Space House, 43-59 Kingsway 2021/1058/P & 2021/1097/L

Delegated Report		Analysis sheet		Expiry Date:		08/06/2021	
(Members Briefing)		N/A / attached		Consultation Expiry Date:		11/04/2021	
Officer				Application Numbers			
Laura Hazelton				(i) 2021/1058/P (ii) 2021/1106/L			
Application Address				Drawing Numbers			
Space House 1 Kemble Street and 43-59 Kingsway London WC2B 4TE				Please refer to decision notice			
PO 3/4		Area Team Signature		C&UD		Authorised Officer Signature	
Proposals							
<p>(i) Variation of conditions 2 and 3 (approved drawings), 5 (long stay cycle parking), and 7 (Electric vehicle charging points) of planning permission reference 2019/2773/P granted 26/11/2019 for the erection of extensions to tower and Kingsway blocks, new glazing to the existing enclosure of the southern external stair on Kingsway; enclosure of the redundant petrol filling station area; façade cleaning; new landscaping and public realm works and internal alterations to both buildings in connection with their refurbishment and change of use from Class B1 offices to Class A1/A3 and flexible Class B1 / events space (sui generis) (summary). Amendments include: external and internal design

Existing Listed kidney bean structure

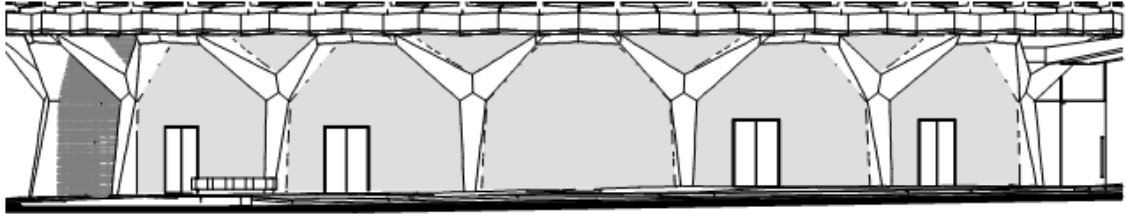
Existing louvres to be replaced with new louvres and a louvred door for access to the fuel cabinet

- 4.31 In order to avoid locating a visible fuel cabinet within the public realm, it is proposed to utilise the existing kidney shaped structure to the west of the site. The existing vent within the structure is not required and the shaft below creates a services link to the basement plant rooms which would be utilised to house the fuel intake cabinet and pipework for the emergency generator at basement level 2. The existing louvres would be replaced with new louvres and concealed louvered. The structure would be refurbished and the mosaic tile cladding cleaned, overall improving its appearance and bringing it back into utilitarian use which is considered appropriate.

Proposed UKPN Facade - North Elevation

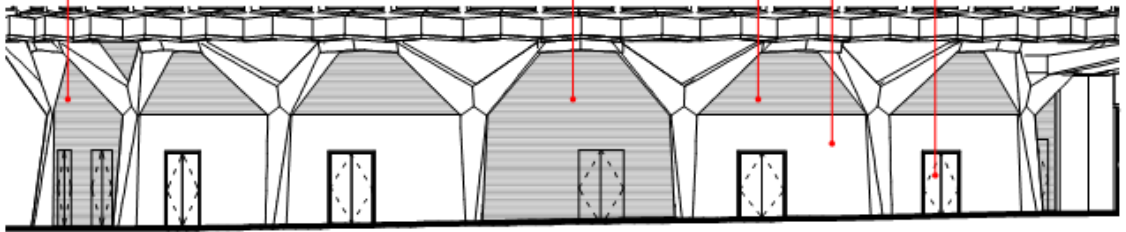
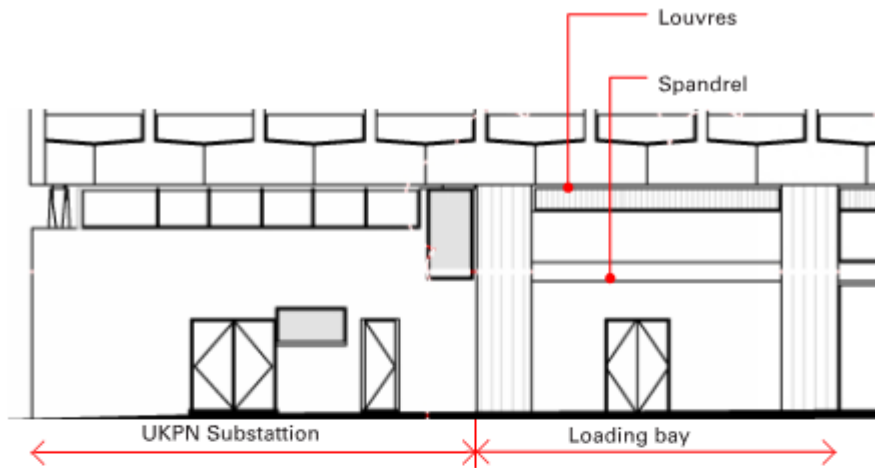
- Existing doors to be made good
- Existing brickwork to be made good
- New UKPN approved louvres to match existing
- Existing louvres and doors retained and repainted

- 4.15 The amended proposal is for the existing UKPN louvres to be retained and repainted, with the existing brickwork below the louvres cleaned and made good and the existing doors into the transformer rooms repainted. Additional louvres would be added at high level, with additional louvered doors added into the full height bank of louvres to the east of the Tower for the emergency escape route for the office levels. The proposals would have a neutral impact on the special interest of the listed building and on the setting of the Kingsway Conservation Area.

Proposed basement level 2 floor plan

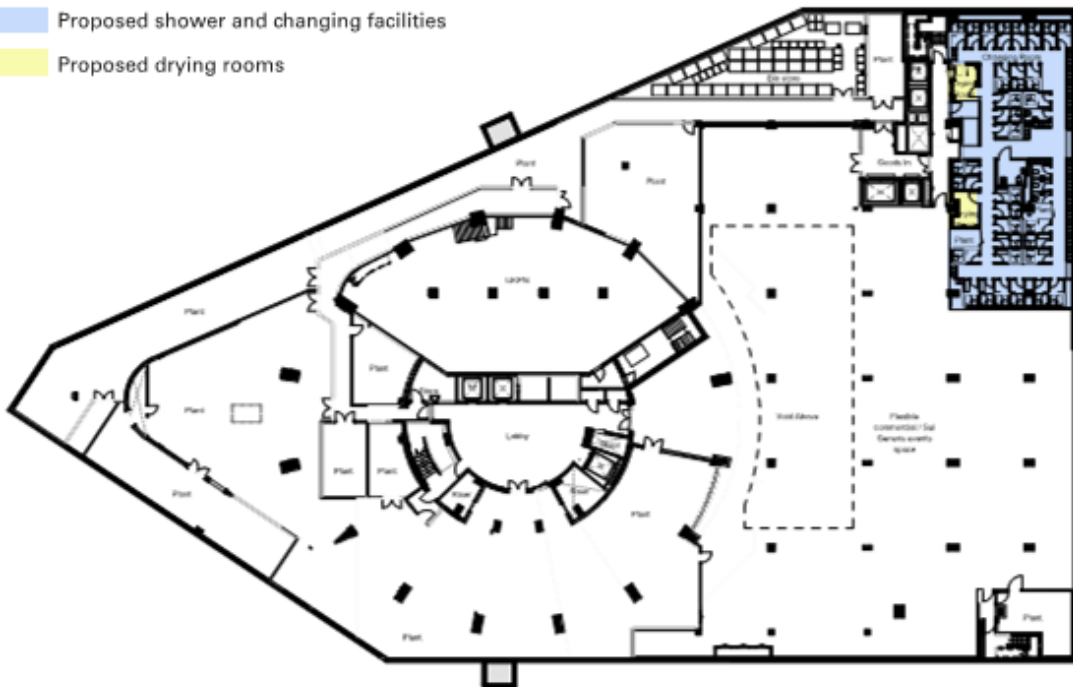
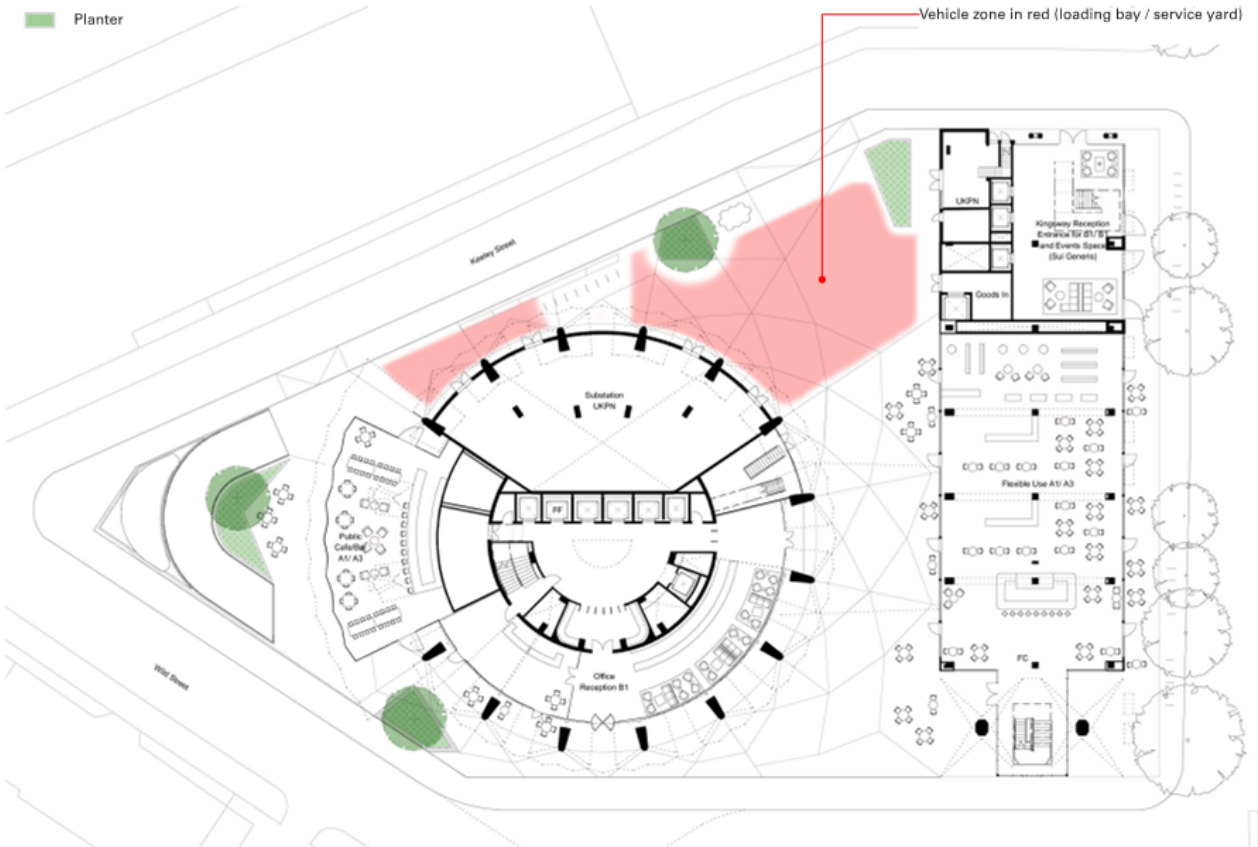
- Proposed shower and changing facilities
- Proposed drying rooms

- 4.27 Revisions are sought to the approved layouts of basement levels 1 and 2 in order to improve the function and operation of the development for future occupiers. The approved design had a large plant room in the north east corner of basement level 1, however the MEP detailed design development has resulted in the need to split up the plant room into smaller rooms and redistribute them around basement level 1 in order to improve the operational function of the proposed development. Other changes include the introduction of a new circulation corridor between the two buildings, additional goods lift between the Kingsway basement and ground floor, reconfigurations of WCs, and additional ductwork and risers. The changes to the layout would result in a reduction in the volume of listed fabric to be demolished at basement level compared to the approved scheme.
